NEW YORK HARBOR
CHANNEL NAVIGATION IMPROVEMENT 50 FT PROJECT
AMBROSE CHANNEL

CONTRACT2
S–AM–1
W912DS–05–B–0012

Symbol	Description	Date	App.
A	Revised Plan sheets No.3,4,5,6,8,9,10,11,12 and cross sections sheet No.13,14 and15	8/8/05	G.A.
B	Sheet C-33 and C-34 are eliminated and sheet numbers are renumbered accordingly 1 thru 35, and Alignment Data sheet All Plan Sheets and Cross sections sheets are revised.	7/19/05	G.A.

COVER SHEET,GENERAL PLAN AND INDEX TO DRAWINGS

PLAN SHEET STA.461+97 TO STA.533+72

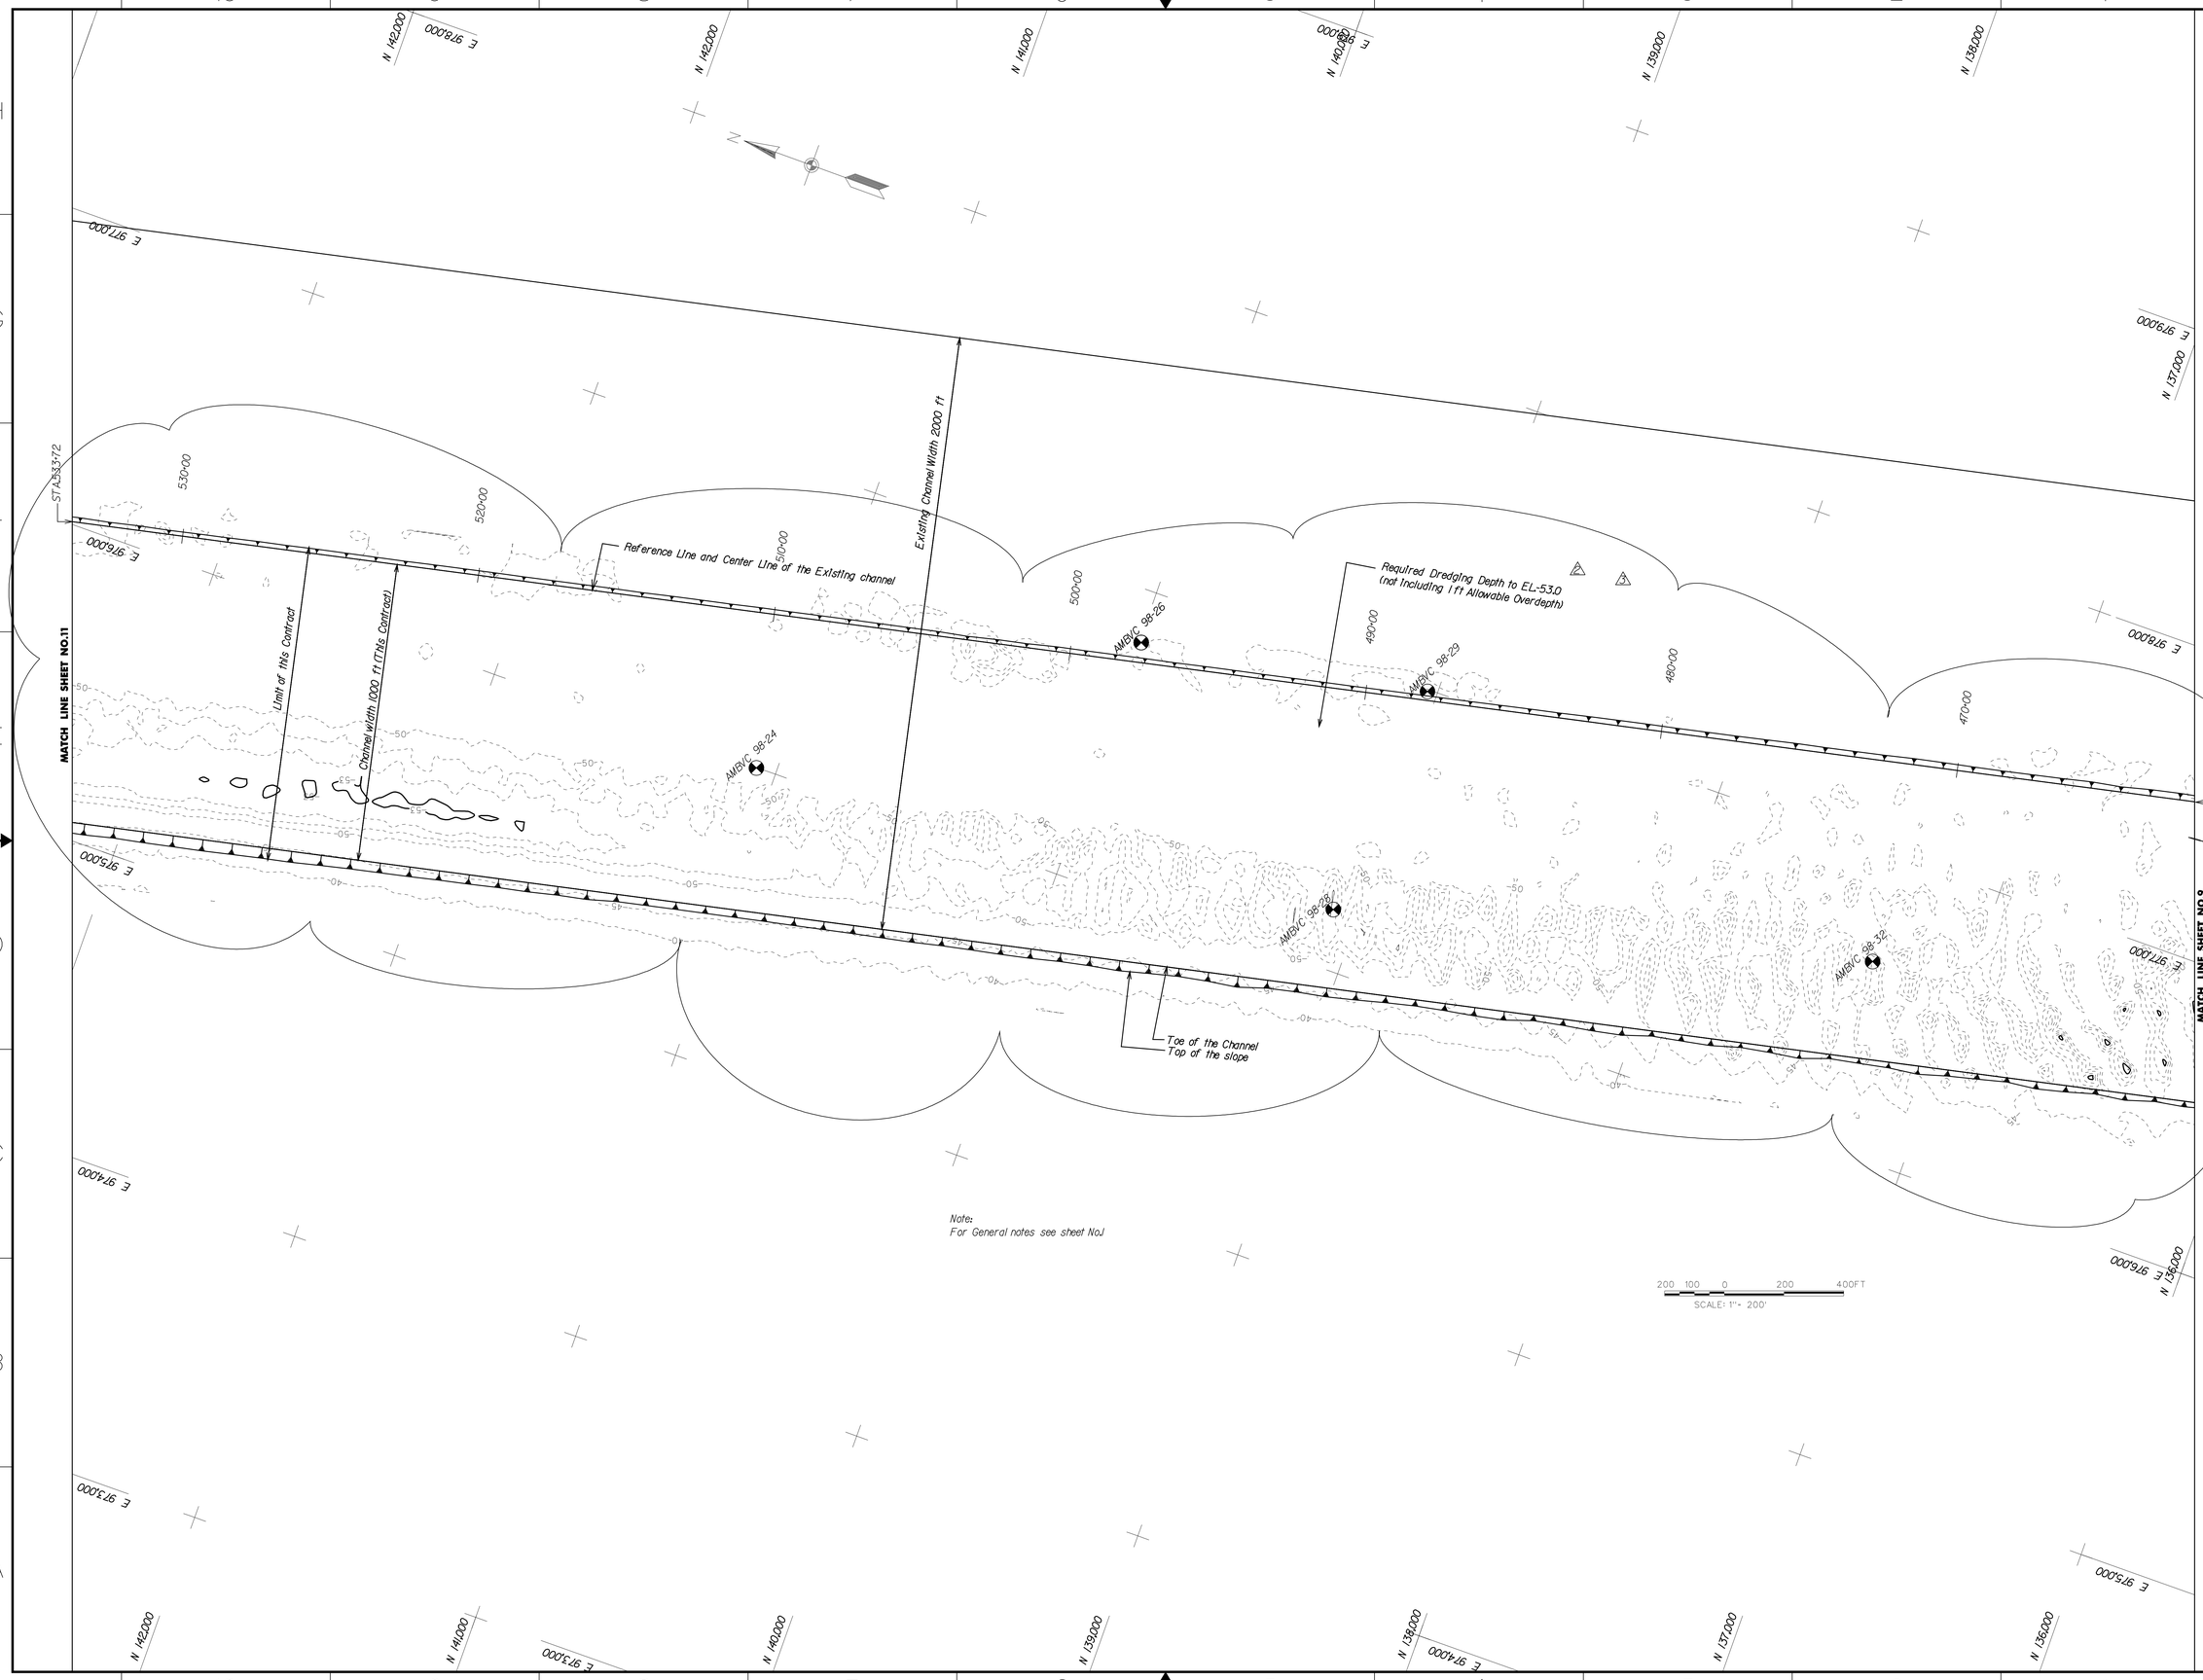
Symb.	Description	Date	Appr.
1	Revised Allowable Overdepth and side slope	8/8/05	G.A.
2	Revised Allowable Overdepth	7/19/05	G.A.

PLAN SHEET ST A533+72 TO ST A605+48.7

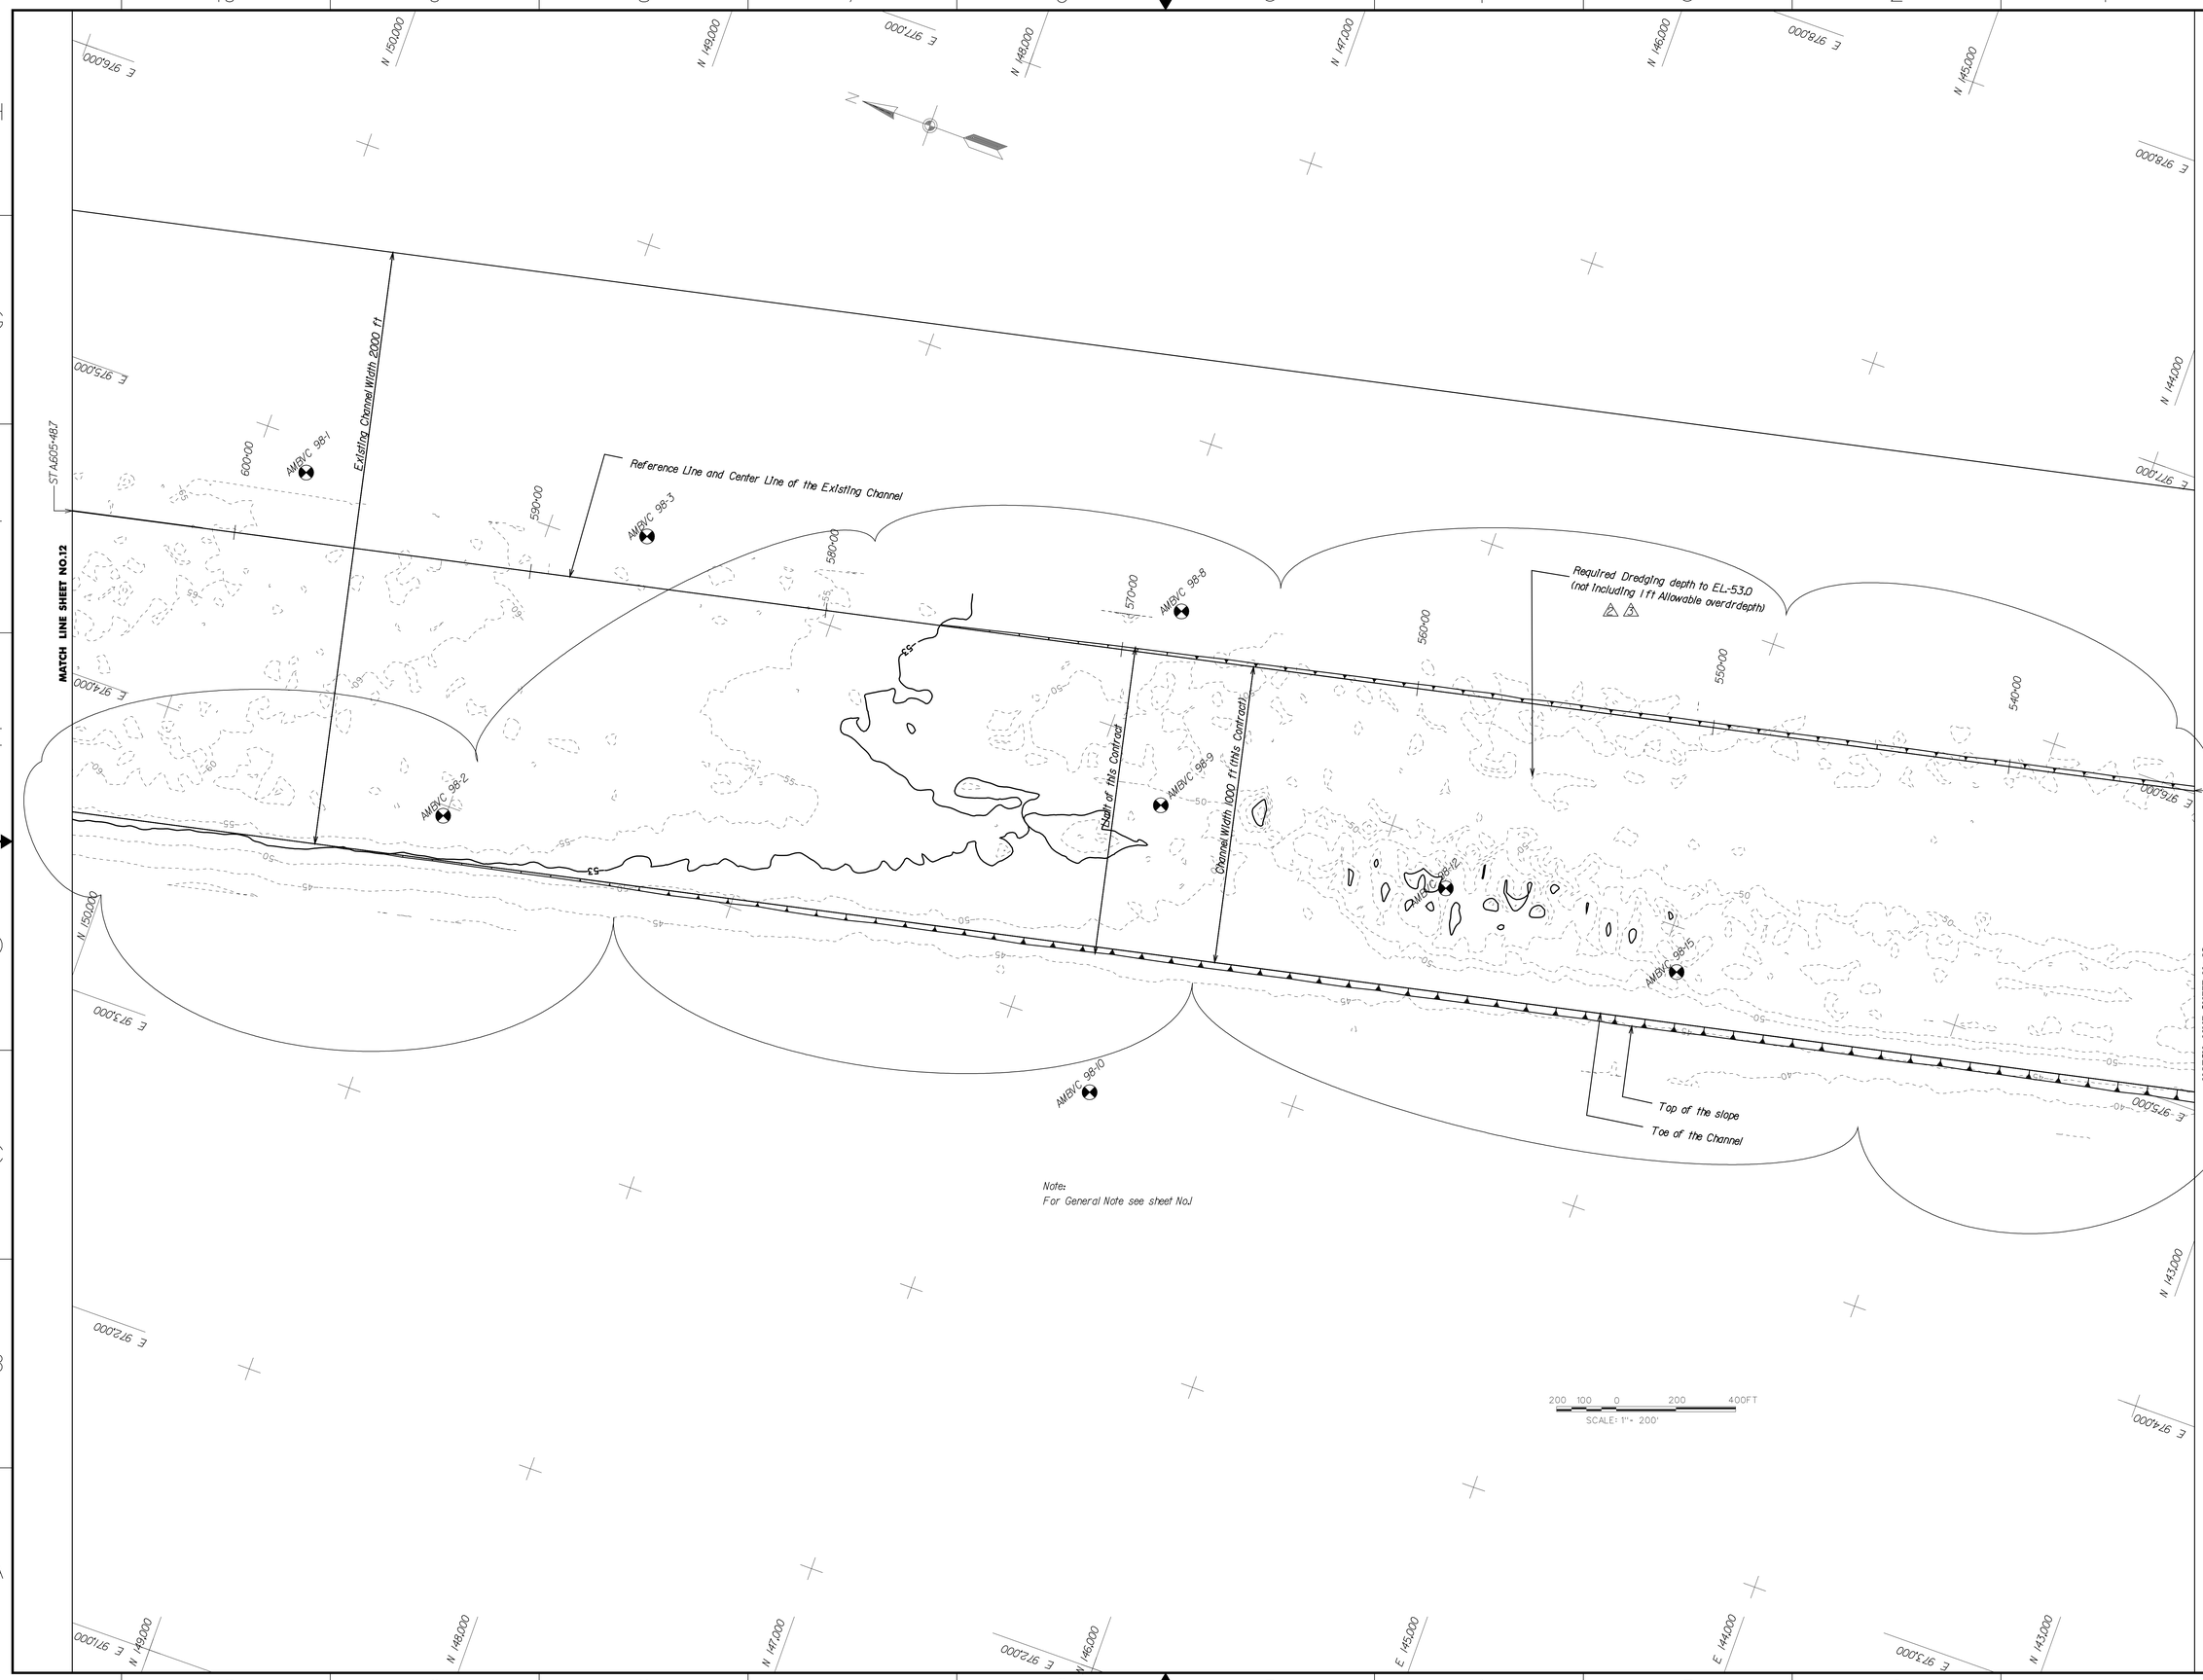
Symbol	Description	Date	Appr.
2	Revised Allowable Overdepth and side slope	8/18/05	C.A.
1	Revised Allowable Overdepth	7/19/05	C.A.

PLAN SHEET STA605+48.7 TO STA666+00

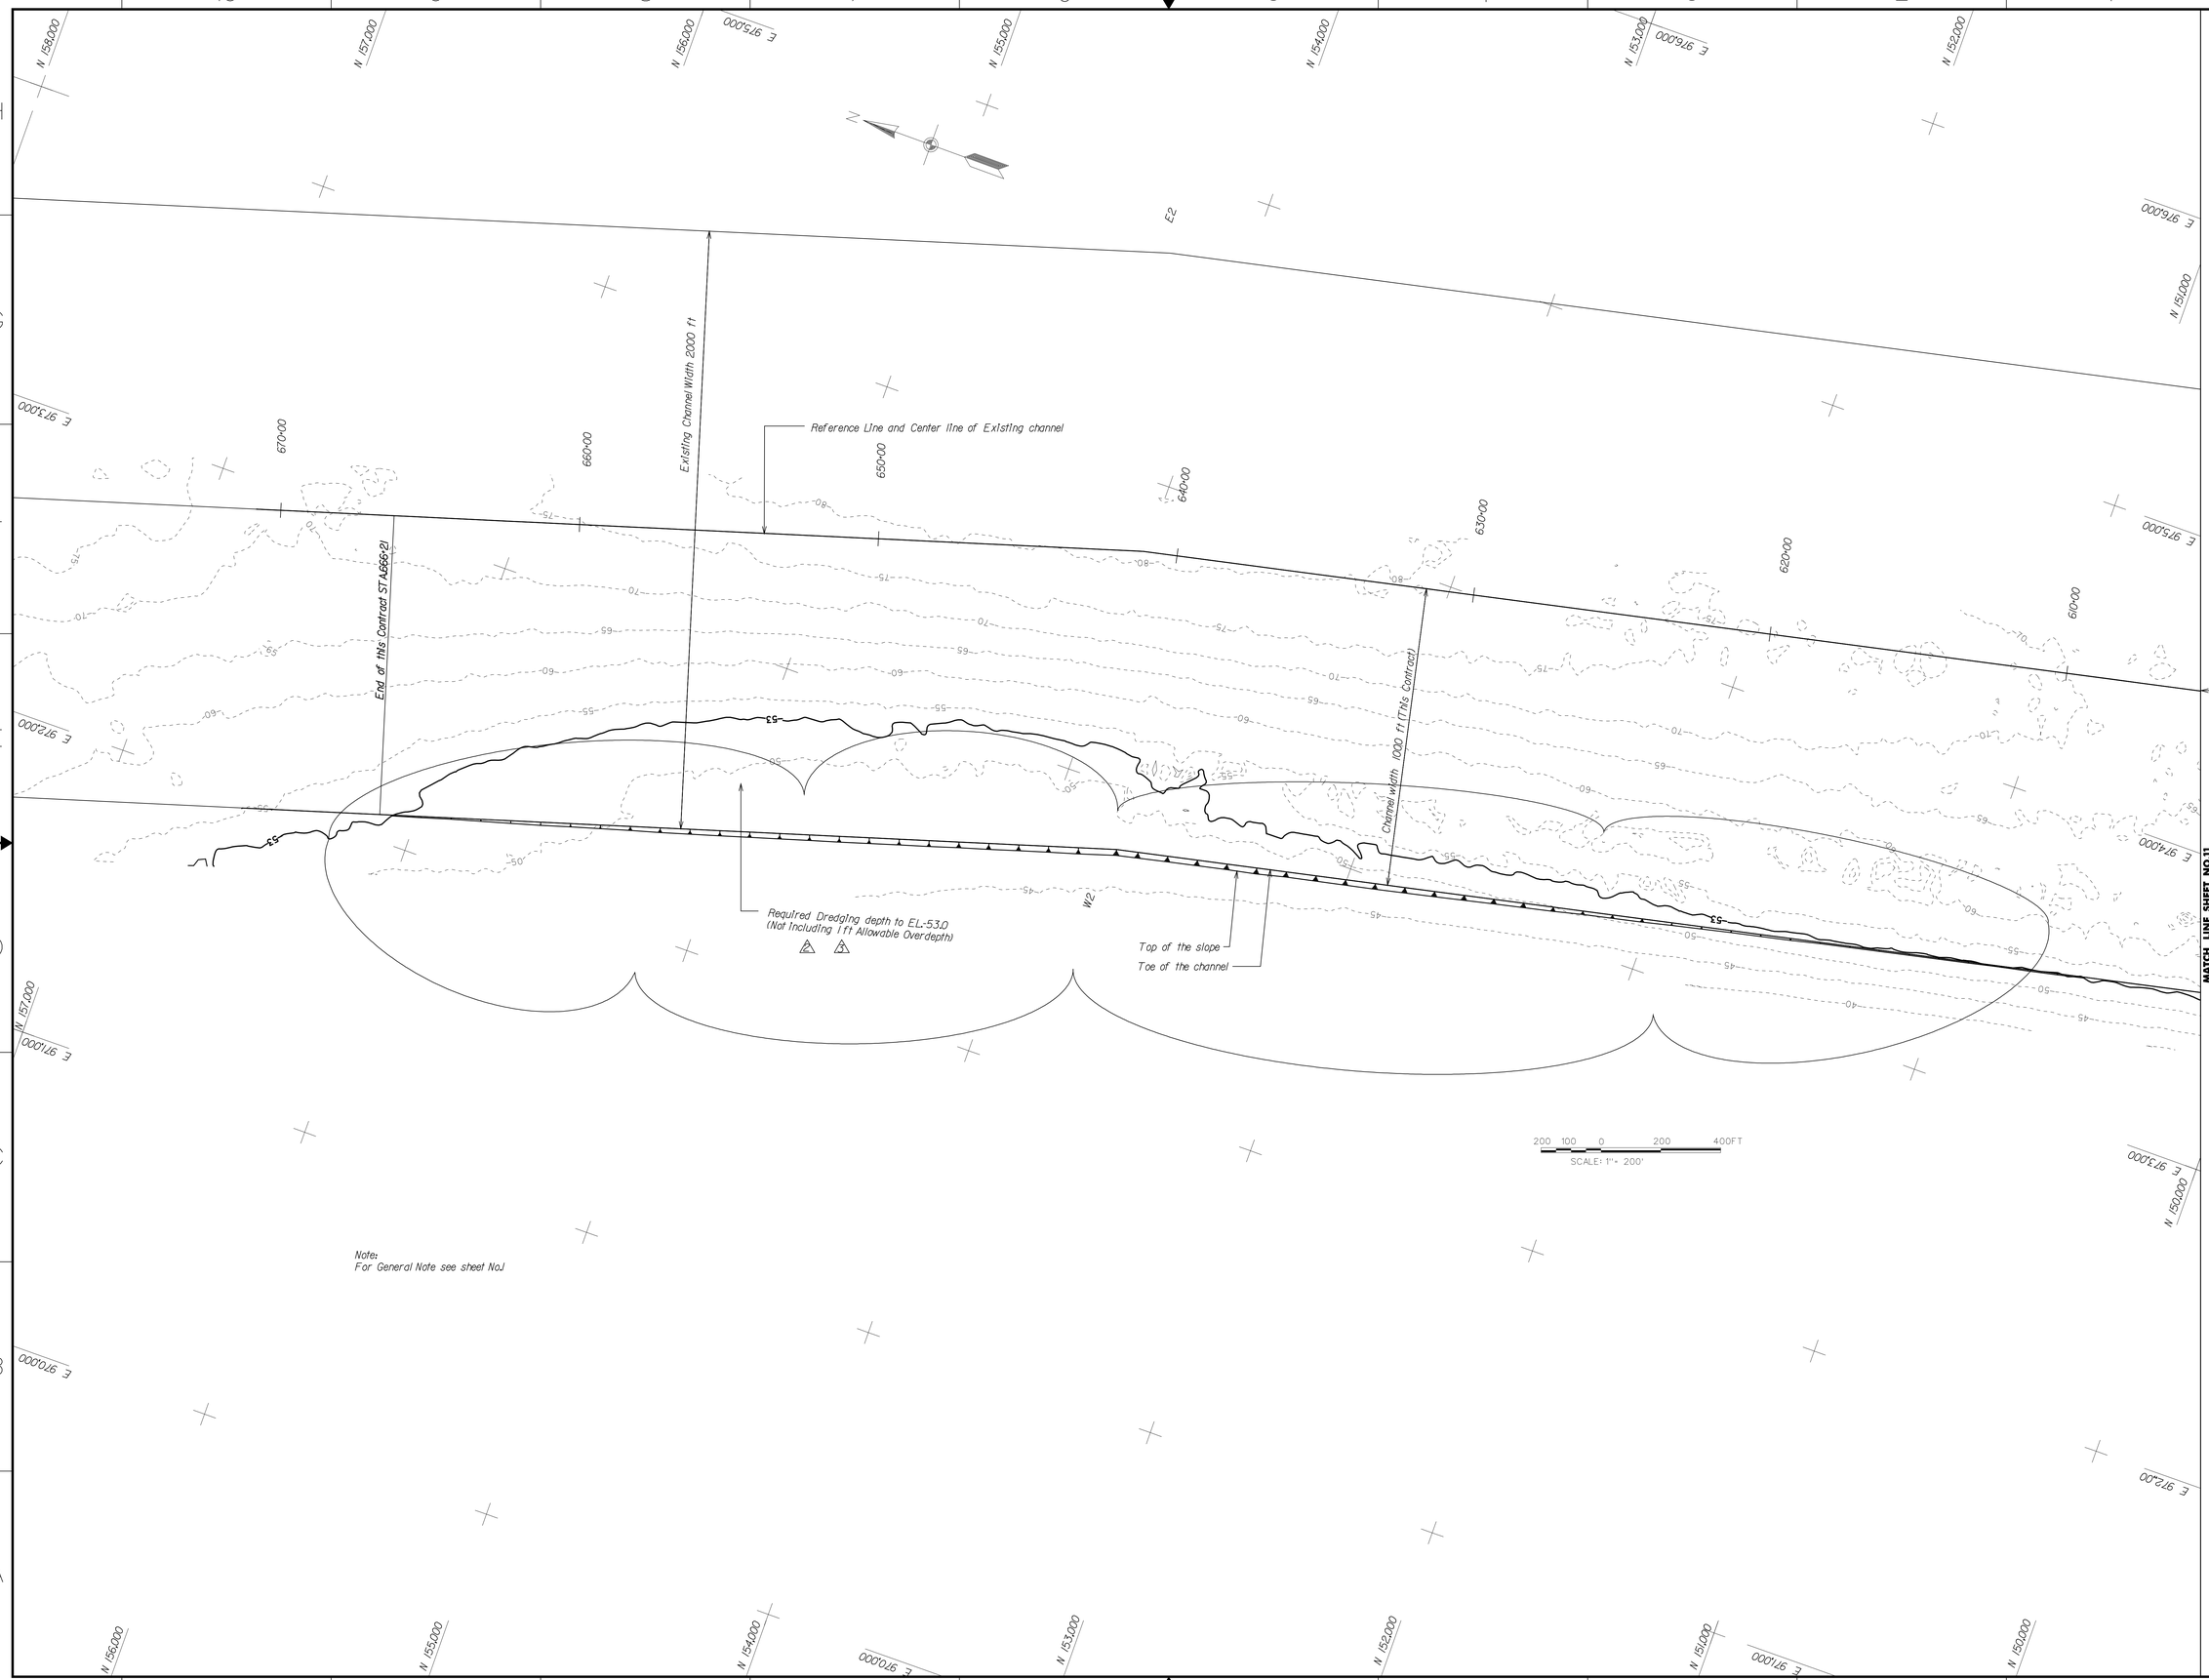
Symbol	Description	Date	Appr.
2	Revised Allowable Overdepth and side slope	2/18/05	G.A.
1	Revised Allowable Overdepth	7/08/05	G.A.
